Delegated officer report for planning application

Application no. 136579/LP/2023

Proposal: Part A - Single storey rear extension and Part B - Hip to gable conversion and addition of dormer to rear roof slope

Address: 1116 Rochdale Road, Manchester, M9 6FQ

Image 1 Existing Ground Floor Plan

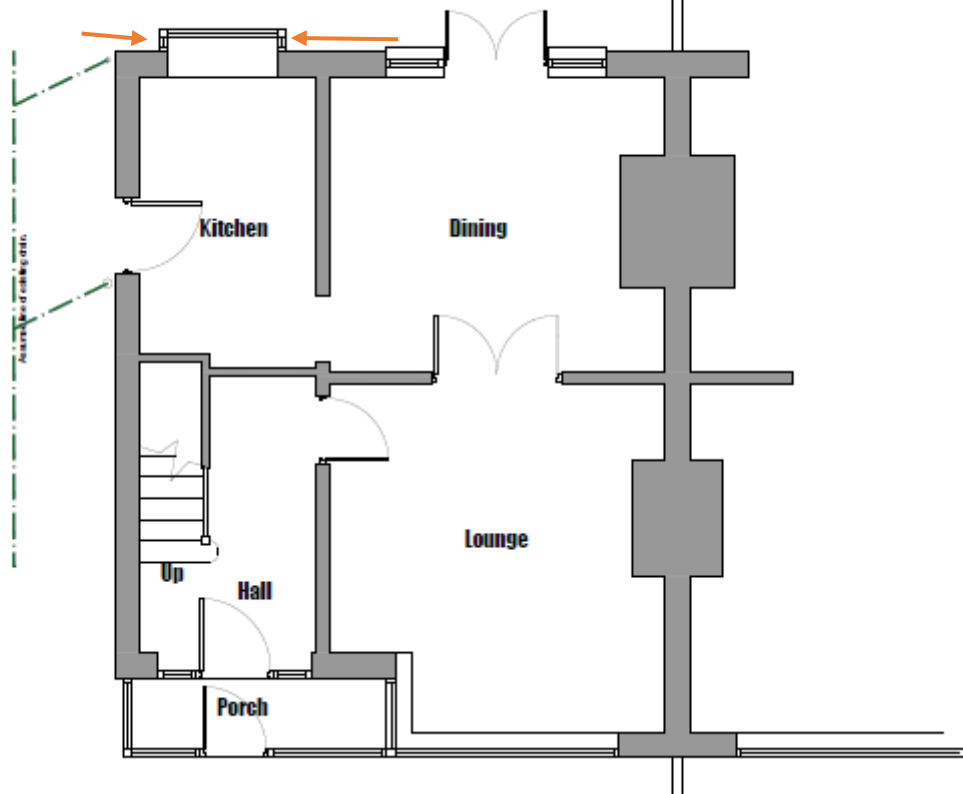
(iii) have a width greater than half the width of the original dwellinghouse; or	No
<u>Explanation</u> As shown in the image and photograph below there is an existing rear bay window that appears to be a common feature of the properties on Rochdale Road. The bay window consequently provides usable floorspace at the property and orange arrows have been added to the ground floor plan shown on image 1 which identify each of the side walls of the bay window. Whilst the bay window would be removed or modified as part of the proposal, the development would consequently extend beyond a wall forming a side elevation of the original dwelling and result in an extension with a width of 6.20 metres when the development is taken as a whole. Therefore, the proposed extension if built would have a greater width than half the width of the original dwellinghouse and would not comply with A.1 (j)(iii) of the GPDO.

2) Refuse Part A on the basis that the single storey rear extension as shown on drawings 705-07 dated 02.02.23, 705-08A dated 03.01.23, 705-09A dated 03.01.23 and 705-12A dated 02.02.23, does not constitute permitted development, as it fails to accord with Part 1, Schedule 2, Class A.1(j)(iii) of the Town and Country (General Permitted Development) Order 2015 (as amended), as the enlarged part of the dwellinghouse would extend beyond a wall forming a side elevation of the original dwellinghouse, specifically the side elevations of the single-storey rear bay window and would have a width greater than half the width of the original dwellinghouse.
